**Re: DA-2356-00 West Centertech – Site Plan  
Comment Response Letter #2**

SITE PLAN  
WEST CENTERTECH

WEST CENTERTECH	
SITE ADDRESS:	16001 E. LOCKHEED DRIVE AURORA, CO 80011
PREPARED FOR:	WEST CENTERTECH, LLC PO BOX 472918 AURORA, CO 80047

CATWALK: SECTION A  
N.T.S.

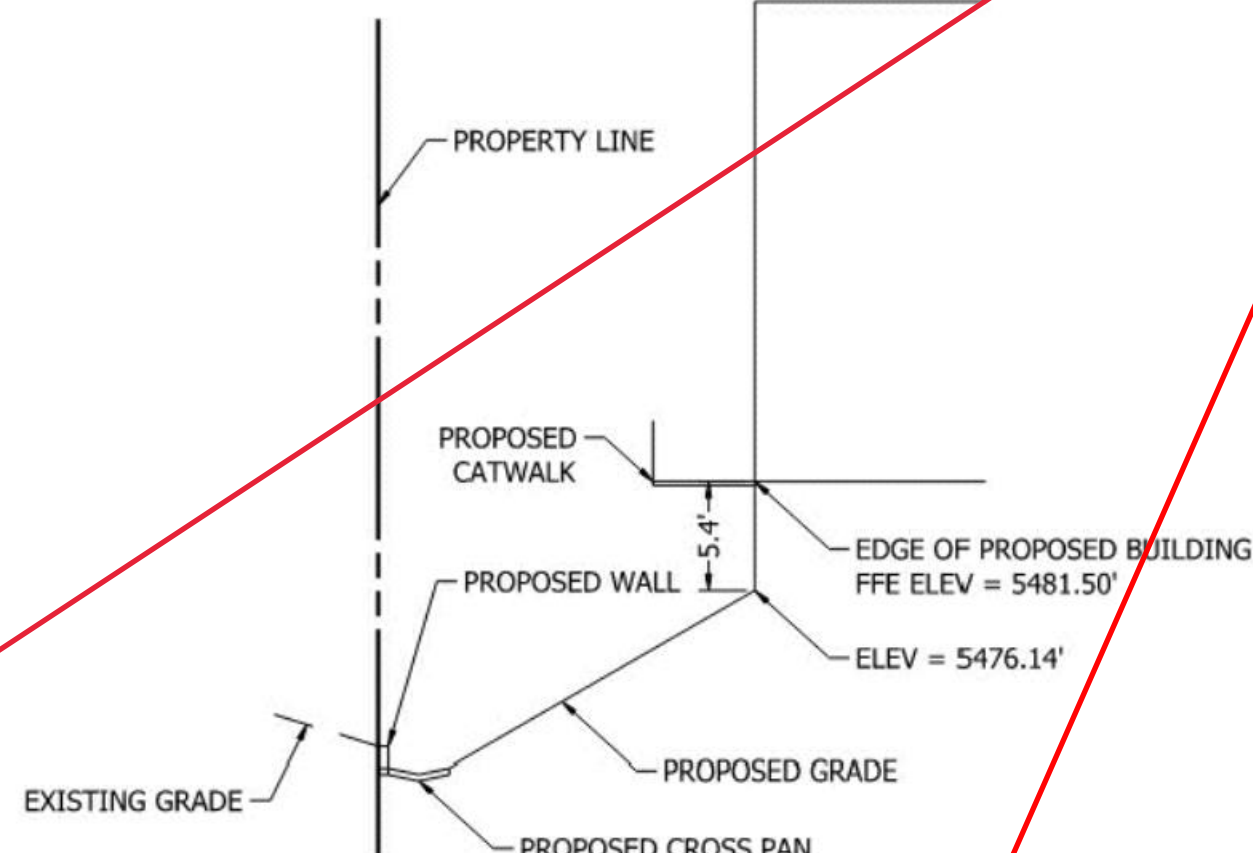
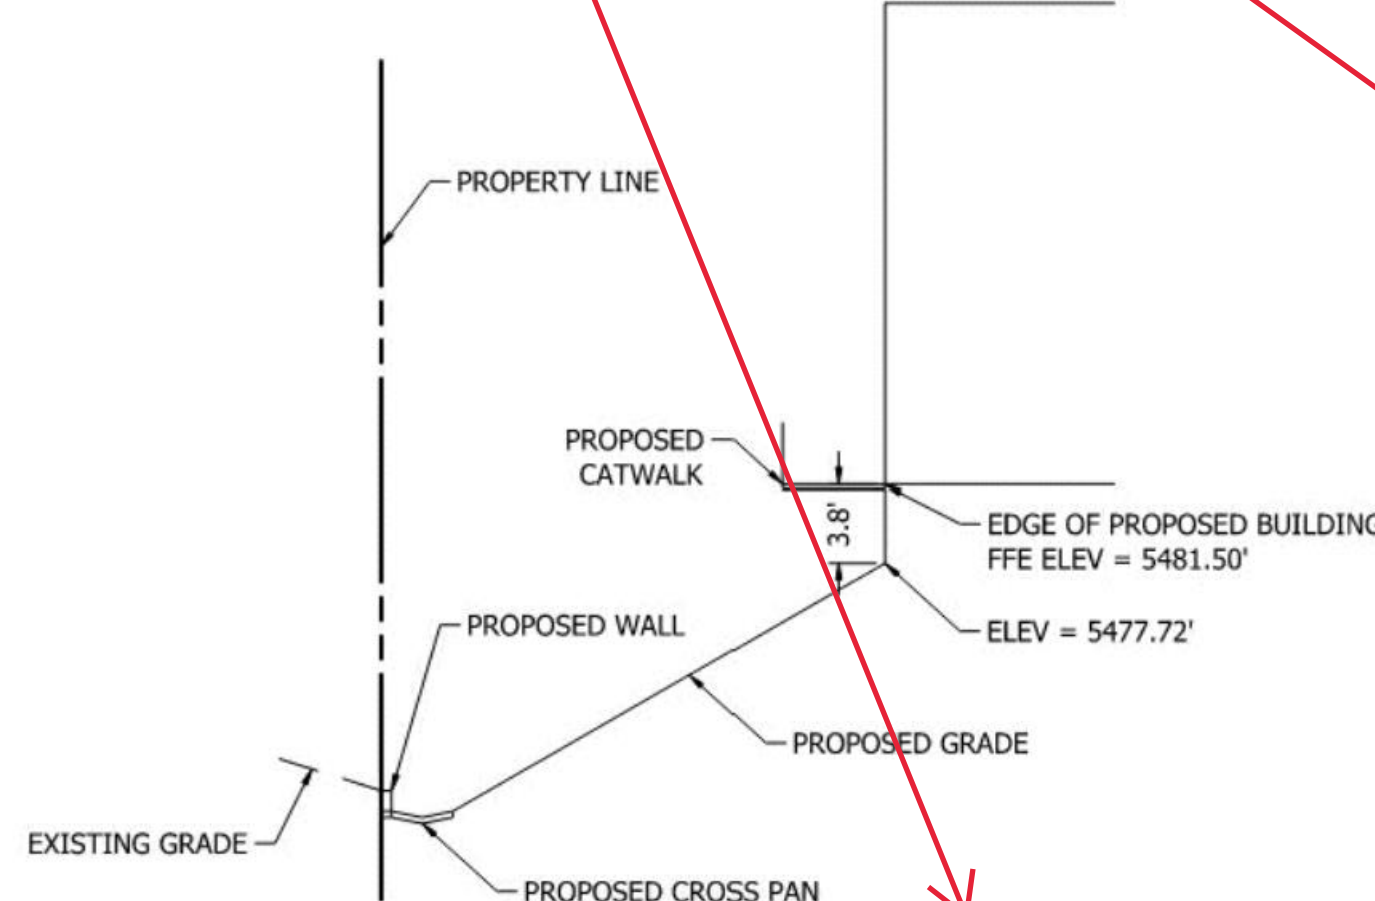
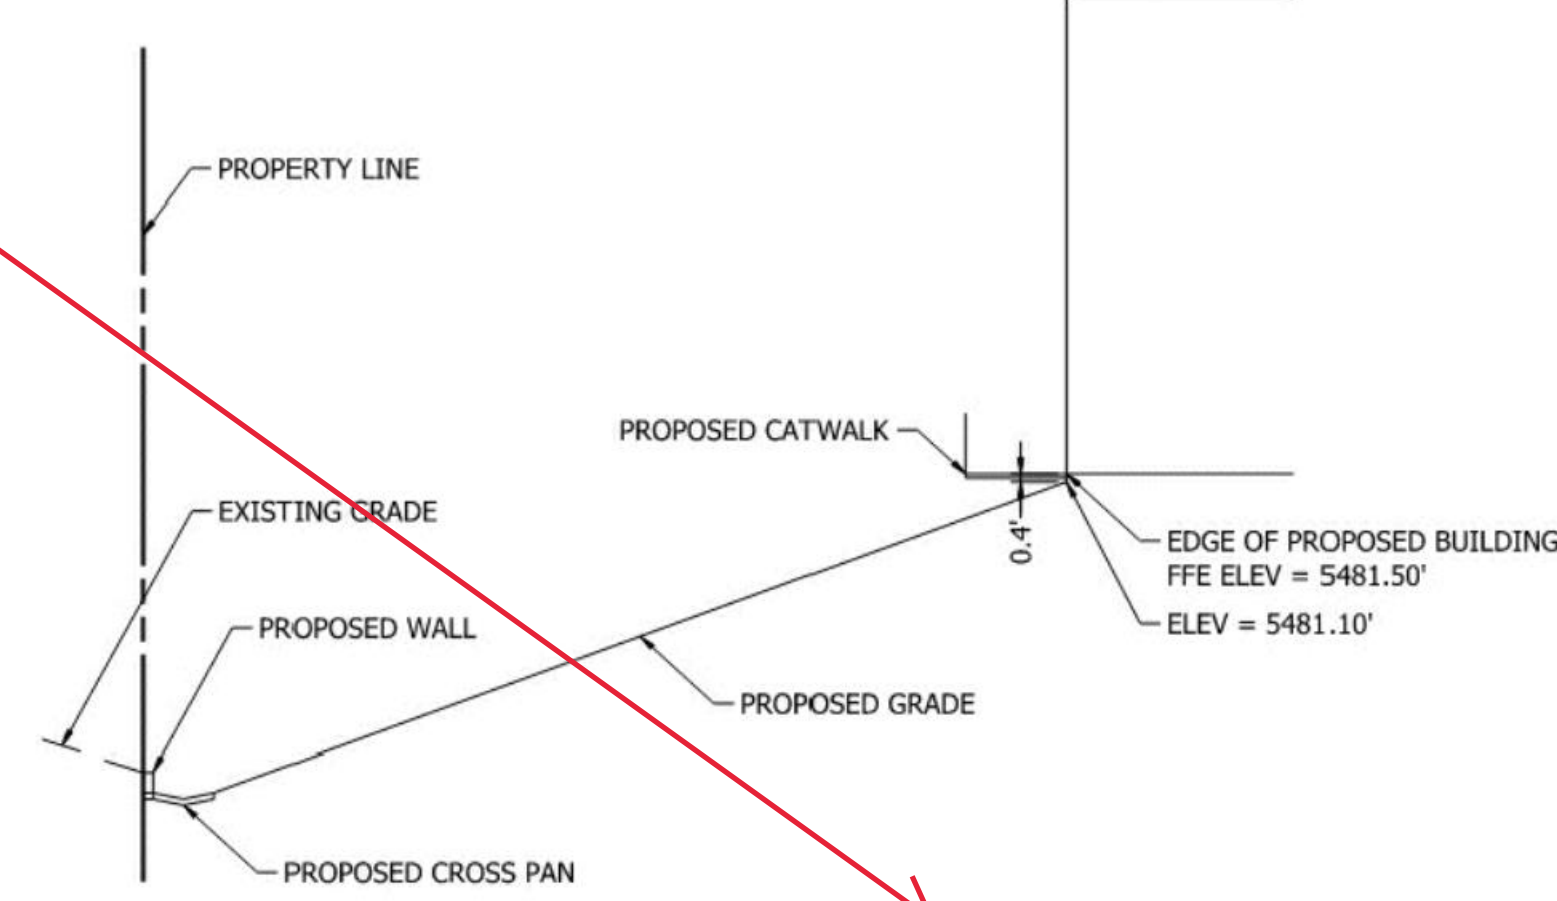
Please provide all proposed grades, existing grades, slopes, fences, walls and sidewalk on all cross-sections. TYPICAL.

Galloway Response: These have been revised per the comment.

AREA SITE LIGHT DETAIL  
FIXTURE "SP1"  
SCALE: NOT TO SCALE

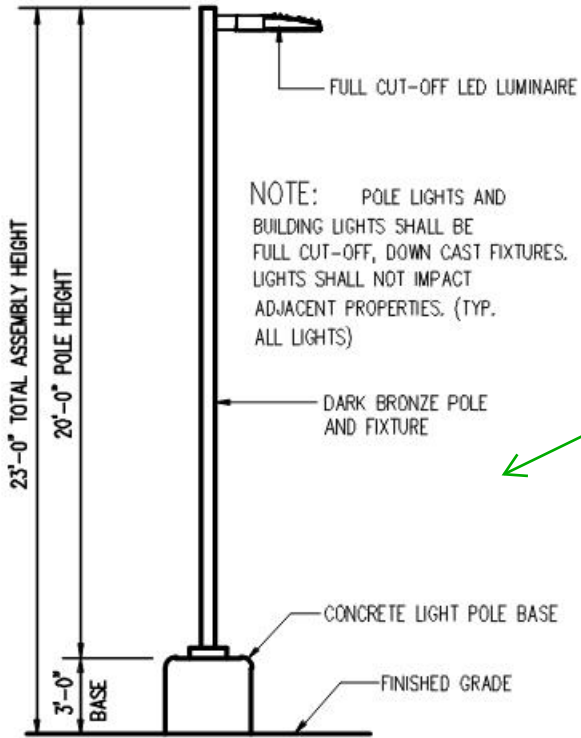
Repeat comment:  
Indicate this on site lighting  
only. COA Standard for public  
street lighting.

Response: Note added  
to sheet.

Response: Label added  
to note and fixture
